**CITY OF KELOWNA**

**MEMORANDUM**

**Date:** April 5, 2024 *revised April 4, 2024*  
**File No.:** Z22-0043  
**To:** Suburban and Rural Planning (TC)  
**From:** Development Engineering Manager (NC)  
**Subject:** 394-396 Moubray Rd

MF1 to MF2

drawing title  
**SITE PLAN - OVERALL**  
 designed PS scale 1/8" = 1'-0"  
 drawn KA  
 checked PS  
 drawing no.

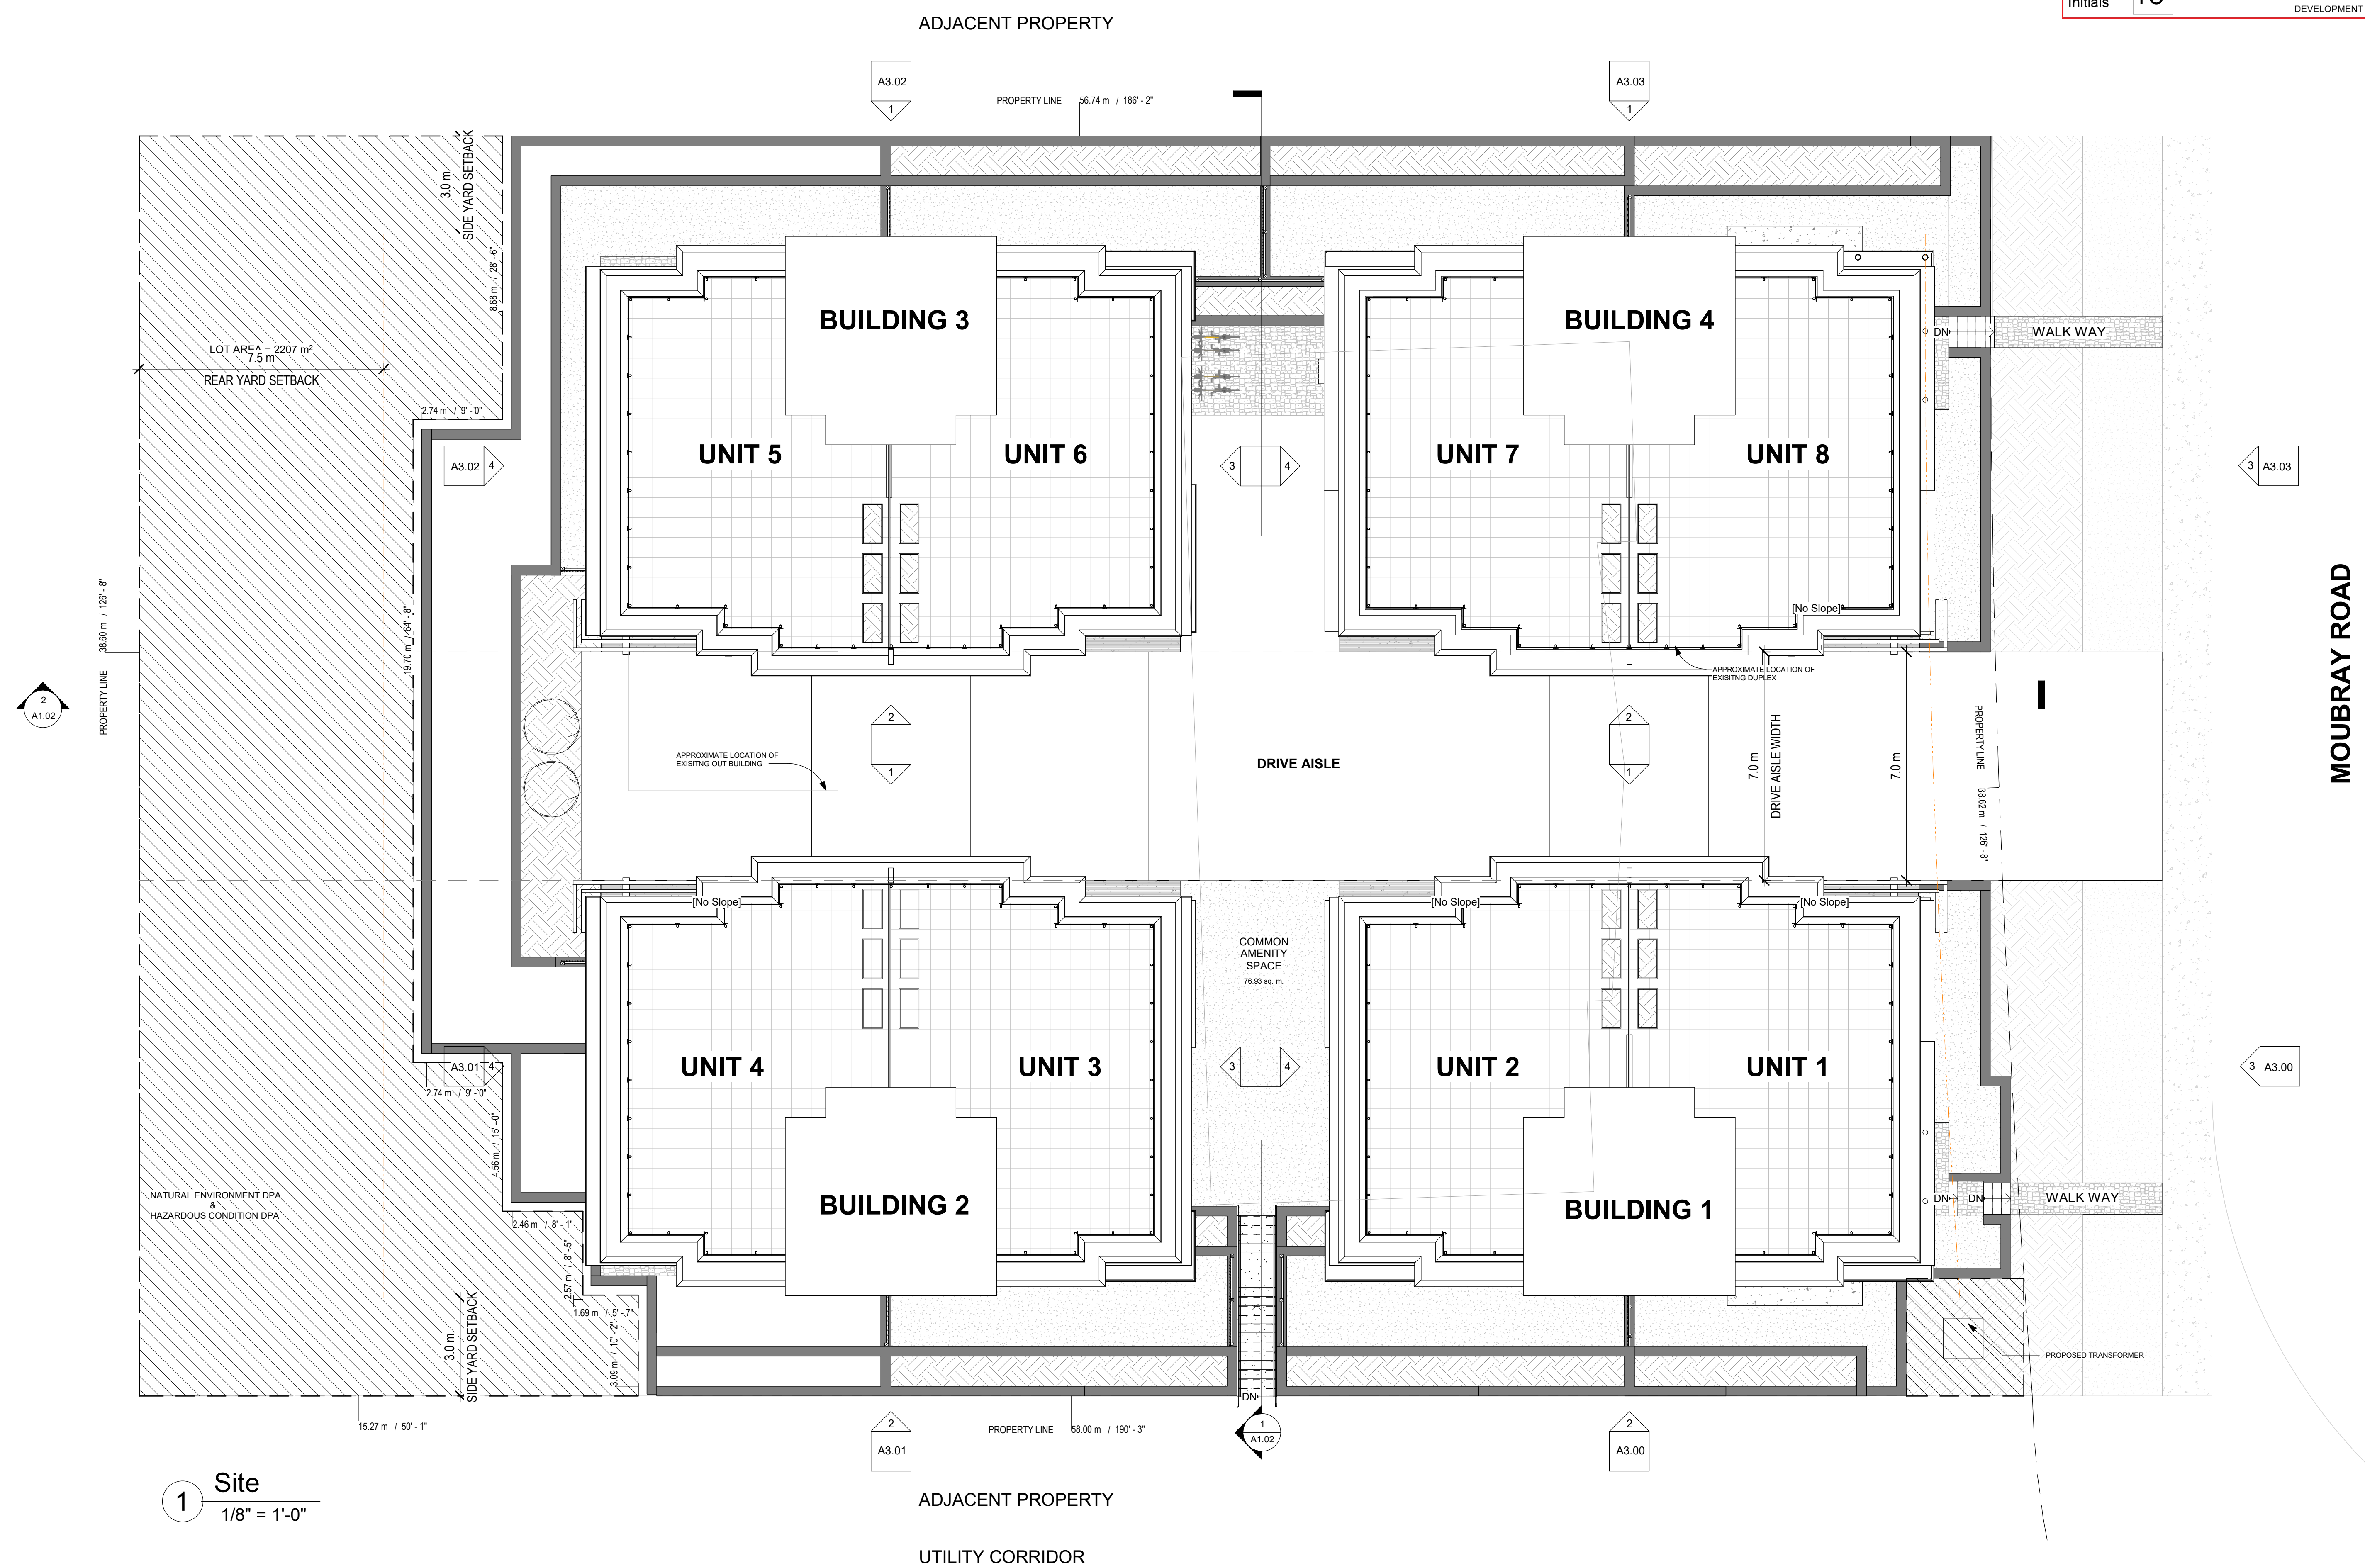
- a. Only one driveway, of maximum 6.0m width, will be permitted. Driveway must access from Moubray Rd. Letdown to be constructed to SS-C7.
- b. The proposed driveway configuration appears consistent with this requirement.
- c. Indicate, on the site, the locations of the garbage and recycle bins. Provide turning movements for an HSU vehicle to confirm maneuverability on site without requiring a reverse movement onto public roads.
